SERVICE NOTE

Agilent 43521A Downconverter Unit

RF Input Attenuator and RF Cable Part Number Change

Figure 1 Top View of 43521A

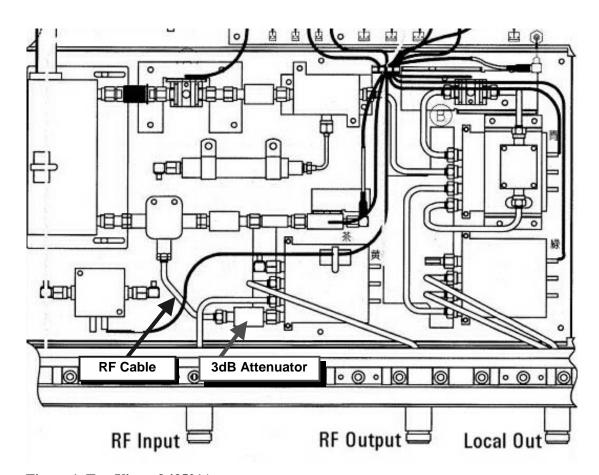
The 3 dB RF input attenuator (8493B #003) of the 43521A has changed to a new type attenuator (P/N 5185-3733). The new attenuator, 5185-3733, is used in all the instruments with serial numbers JP1KG00289 and above. To accommodate the new attenuator, the RF cable for interconnecting the attenuator and power divider was also changed.

Replace both old attenuator and RF cable with the new attenuator (P/N 5185-3733) and RF cable (P/N 43521-61646) as shown in Figure 1.

When the 3 dB input attenuator or RF cable is faulty, replace the attenuator and/or the cable in accordance with the following instruction depending on the instrument serial number.

Replace either the old attenuator or RF cable with the new attenuator (P/N 5185-3733) or RF cable (P/N 43521-61646). (That is, replace the faulty component only.)
